Diavik Diamond Mines (2012) Inc.
P.O. Box 2498
Suite 300, 5201-50th Avenue
Yellowknife, NT X1A 2P8
Canada
T (867) 669 6500
F 1-866-313-2754

Subject: DDMI Amendment Request – Surveillance Network Program

Annex 1: Surveillance Network Program

Figure 1 - Drainage basin for Sump E21 and proposed SNP station 1645-87. All drainage from WRSA-SCRP is expected to flow into Sump E21 and not travel beyond this point.

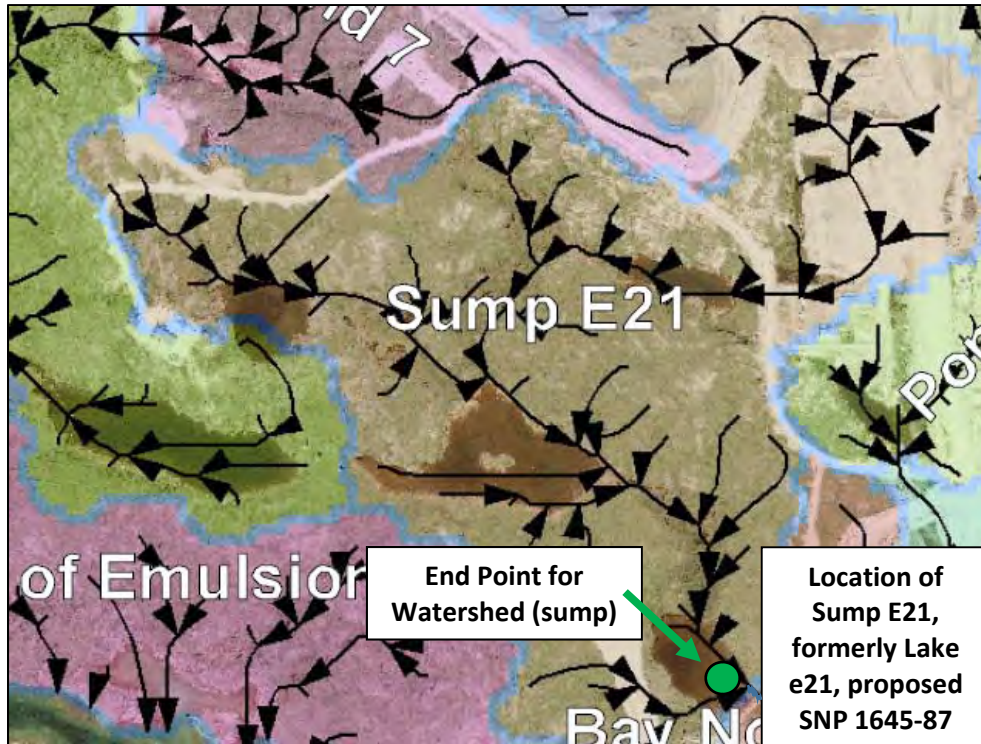
DDMI is proposing the addition of an SNP station (1645-87) for Sump E21 that is designed to capture the seepage and runoff water from the Waste Rock Storage Area-South Country Rock Pile (WRSA-SCRIP). A draft description of the sampling purpose and protocol is included within the SNP and a map showing the location of the proposed station is also attached (Attachment-1).

Description:	<u>Sump</u>		
Location:	<u>Sump E21 (formerly Lake e21)</u>		
Sampling Frequency:	Sampled monthly when water is present and ice cover does not prevent the collection of <u>sump</u> samples, or as directed by the Board or Inspector	Once prior to the commencement of Discharge. Discharge cannot occur if there is water or waste from the facilities identified in Part H, Items 21b, 22b, 23d, and only in accordance with Part H, Item 27.	Daily during Discharge
Sampling Parameters:	Total Ammonia, Field Parameters ³ , Total ICP-MS Metal Scan ¹ , Major Ions ² , Nitrate, Nitrite, pH ⁴ , Total Phosphorus, Total Suspended Solids, Turbidity	Total Petroleum Hydrocarbons ⁶ (TPH), PHC (F1-F4) ⁷	TSS, pH ⁴ , Turbidity
Rationale for Station:	<u>To monitor runoff water quality from the Waste Rock Storage Area-South Country Rock Pile (WRSA-SCRP) and site roads, as well as WRSA-SCRP seepage, if present.</u>
